County of Volusia
Office of Recovery & Resiliency

MEMORANDUM

Subject: Floorplan approval correction

Revised Option 1

CUSTOM
FLOOR PLAN - ROOF PLAN

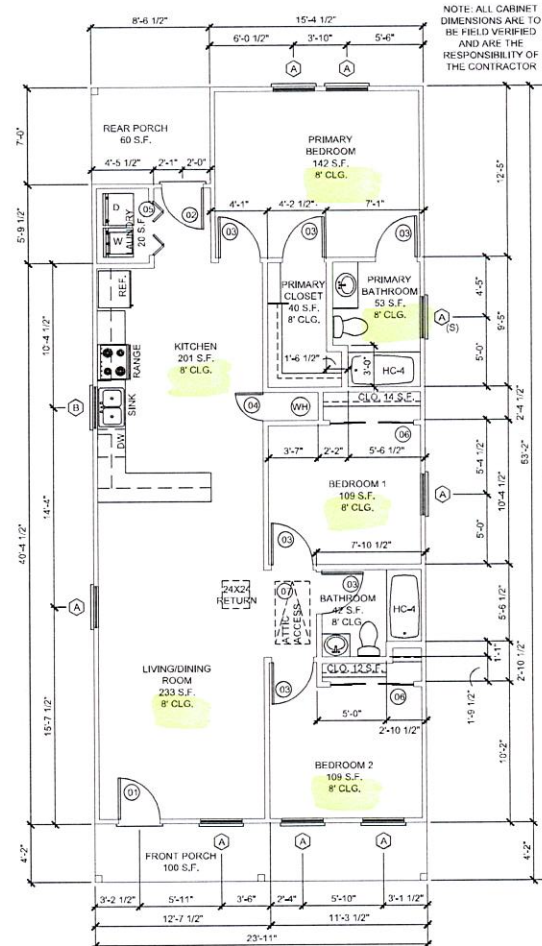
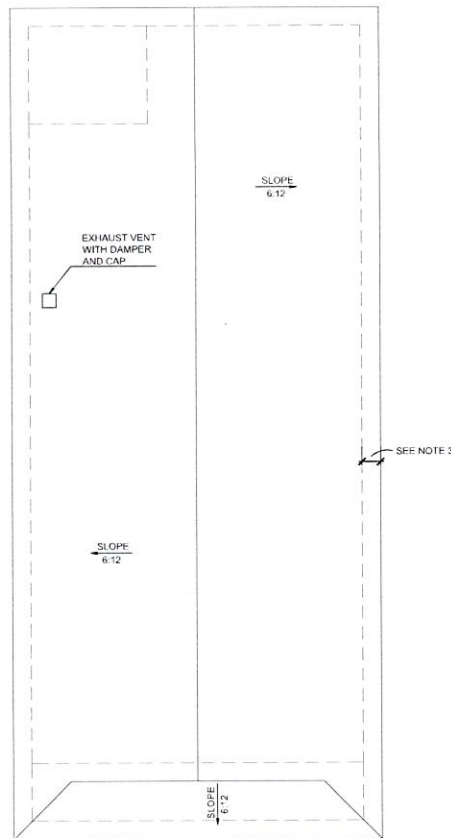
On August 25, 2026, LEMOINE requested the "Option 1" floorplan approval be corrected to reflect that the ceiling height will be 8' instead of the 9' referenced on the initial floorplan.

By signing below, you are authorizing the change to the "Option 1" floorplan with an effective date of August 25, 2026.
